Our Ref: REG GIB GE

**RE: REGENTS GARDENS PADBURY - AMENDED PLANS – MEETING, 09 OCTOBER 2023**

**Figure 4 – Dementia floor modified open space access treatment**

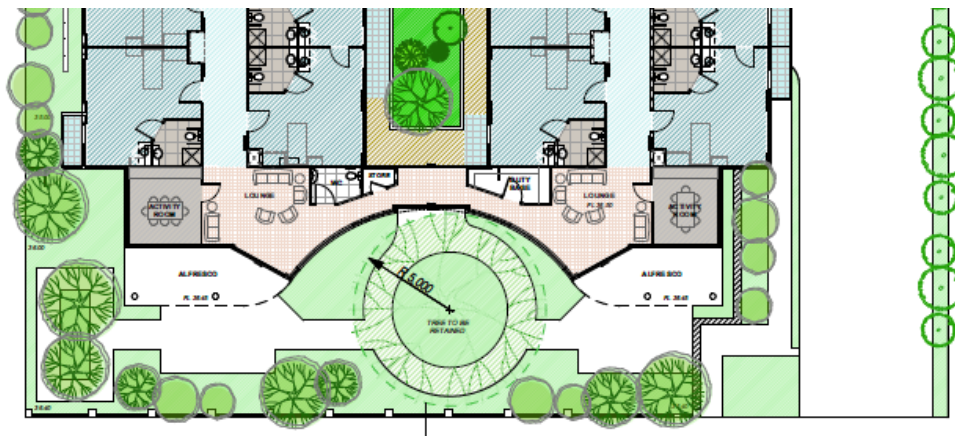
- The void spaces between the wings have been increased to allow additional sunlight and ventilation. The void spaces to the west have been increased from 3.6m to 4.5m wide, and to the east of the building from 3.6m to 6.3m. Additionally, an internal landscaped area has been introduced within the 6.3m wide void space for dementia residents to allow greater flexibility, circulation, and amenity, along with accessibility into the front open space area which provides significant livability improvements for these residents.
